Submission 700 (Acton Town Council, March 11, 2020)

Bakersfield - Palmdale - RECORD #700 DETAIL

Subject: Questions Regarding the Environmental Analyses Conducted for the Bakersfield-Palmdale Segment of the High Speed Rail Project

Reference: Draft Environmental Impact Report/Environmental Impact Statement (EIR/EIS) Released February 28, 2020

CONDUCTOR SURVEY DEPARTMENT OF WATER AND POWER OVERHEAD TRANSMISSION ENGINEERING

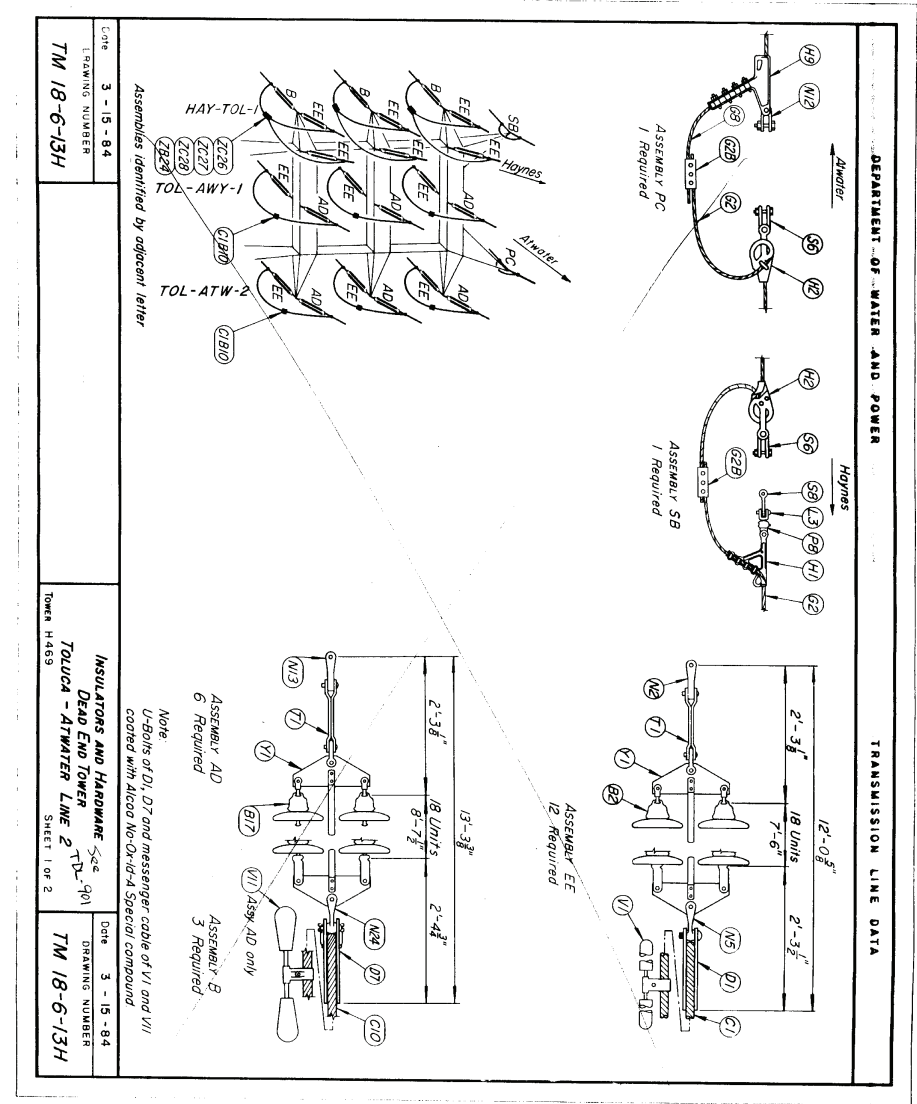
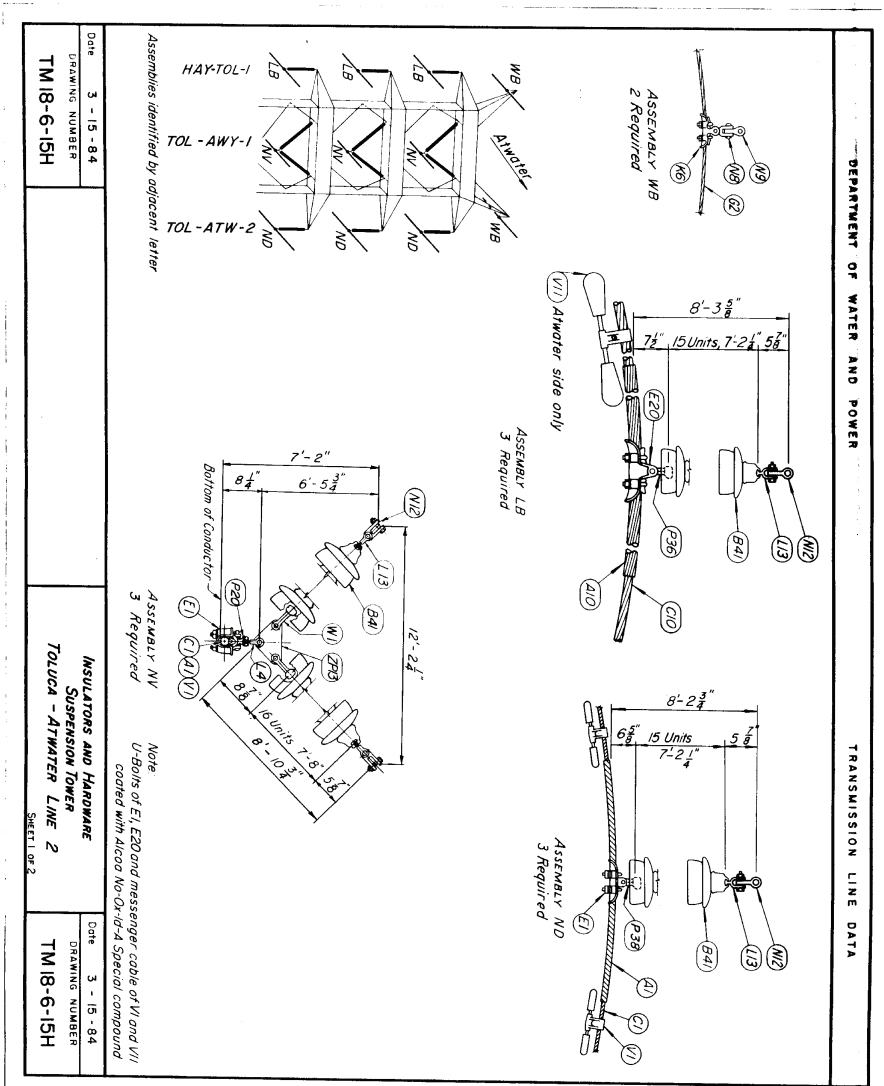
Please perform a survey of each Department transmission line affected by the project. For each span (the section of wire between two (2) towers) provide the following information:

1. The tower numbers of the Department transmission lines related to the span. The tower number is located near ground level on at least one (1) leg of each tower.

CONDUCTOR SURVEY DEPARTMENT OF WATER AND POWER OVERHEAD TRANSMISSION ENGINEERING

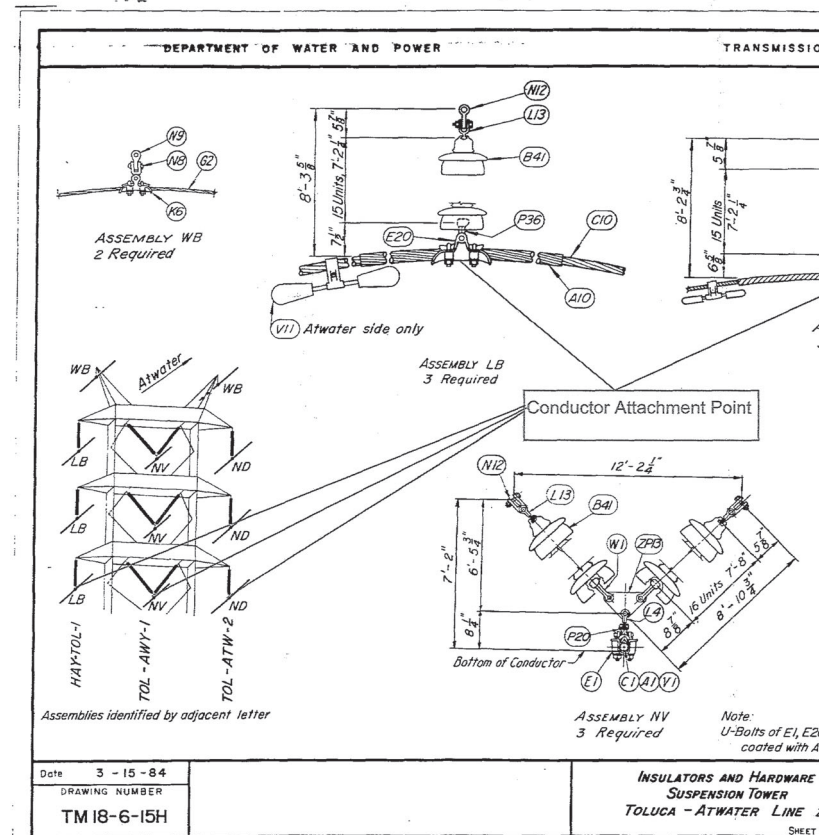
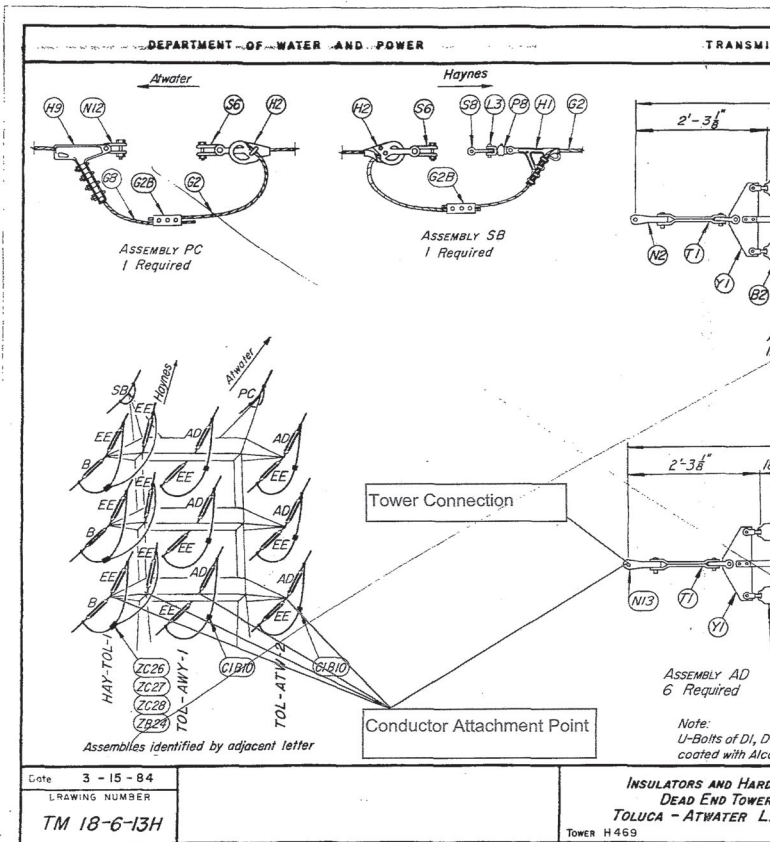
Please perform a survey of each Department transmission line affected by the project. For each span (the section of wire between two (2) towers) provide the following information:

1. The tower numbers of the Department transmission lines related to the span. The tower number is located near ground level on at least one (1) leg of each tower.

2. Survey the top-of-concrete of each footing of each tower related to this survey. For example, a survey involving one (1) span would involve two (2) towers, each with four (4) footings, for a total of eight (8) top-of-concrete shots.
